Gearbox fixation on UL-engines type 377, 447, 462, 503 and 532

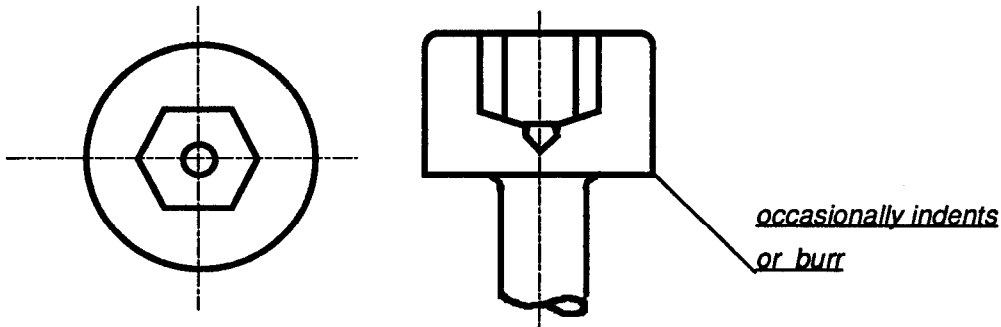
In isolated cases, where heavy propellers were used, screw heads forced into the adapter flange and loosened it.

- a) Screw head contact surface is tapered by 0,2 mm.
Only the outer edge of the screw head is contacting the flange, slackening the screw fit by vibrations.

b) If the plane surface has been damaged (knock marks, grooves), screws may slacken.

If inspection revealed loose adapter plate, then proceed as follows:

- A: Depending on screws mounted:
- Scrap "ABC" screws and order new screws (part no. : see item 1)
 - Rework screws showing indents and or burrs, or order new screws.
- B: Clean all contact surfaces and the bosses on crankcase carefully.

C: The adapter flange has to fit absolutely evenly on the crankcase flange.

D: Coat the contact surfaces between adapter flange and crankcase and the screw threads with LOCTITE 221 (ROTAX part no.899 785).

Coat the contact surface of the screw heads with LOCTITE 648 (ROTAX part no. 899 788)

E: Tighten the screws at 50 to 55 Nm.
